ADDENDUM 2: CLARIFICATION

TENDER FOR SUPPLY OF WELL LOGGING & TESTING EQUIPMENT, LIFTING TRUCK AND ACCESSORIES – REF NO. GDC/GRM/OT/021/2020-2021

36" Bored Raised Face Flange

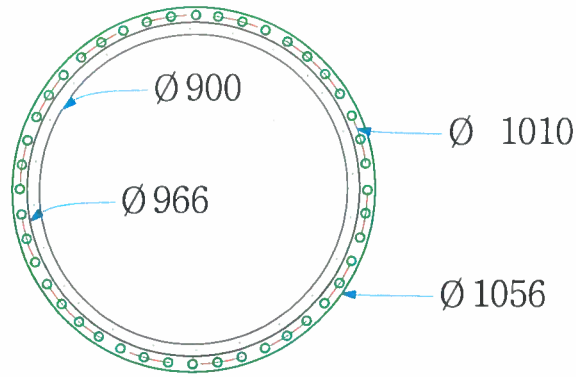
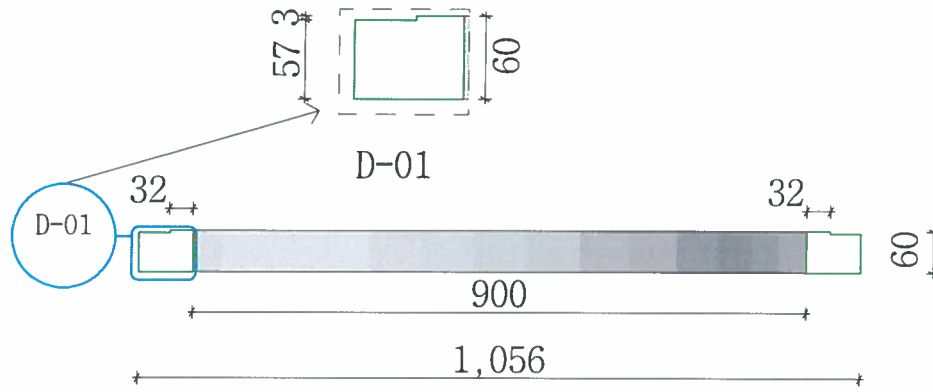
In relation to Item No. 3 Schedule A. For standard of 36" 150LB flanges, according to the standard ASME B16.47/JPI-7S-43-2001, PCD will be 1085.8mm. However, there is specified PCD 1010mm at the technical specification. Please give us clarification?

Give information about the piping size that will be connected to the bored flange?

The flanges are to be manufactured as per the drawings provided.

The piping size is as displayed in the enclosed drawings.
